# Random Misfire Under High Load

**Service Category** Engine/Hybrid System

YEAR(S)	MODEL(S)	ADDITIONAL INFORMATION
2019	Avalon	WMI(s): 4T1 VDS(s): BZ1FB
2018	Camry	WMI(s): 4T1 VDS(s): BZ1HK

**December 11, 2020 Rev2:**

**Figure 1. Location of Authorized Modifications Label on 2019 Avalon**

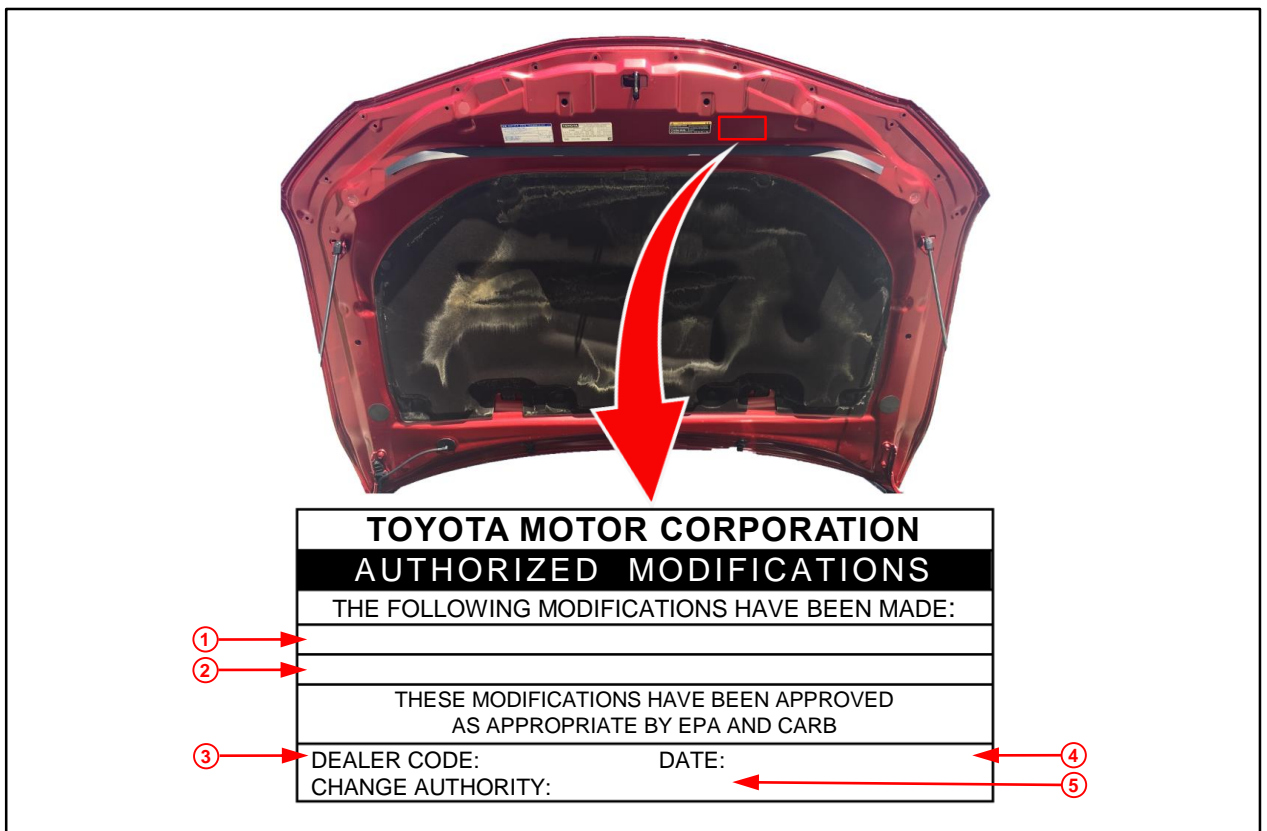
- Use Techstream to confirm if the ECM (PCM) calibration has been updated and check for the Authorized Modifications Label affixed to the vehicle in the location shown below.

Is the calibration ID listed in Techstream and on the label the latest ECM (PCM) calibration?

<b>1</b>	Replacement ECM (PCM) Part Number (e.g., 89661-07664)
<b>2</b>	New Calibration ID (e.g., 896630725400)
<b>3</b>	Dealer Code

<b>4</b>	Date Completed
<b>5</b>	This SB Number
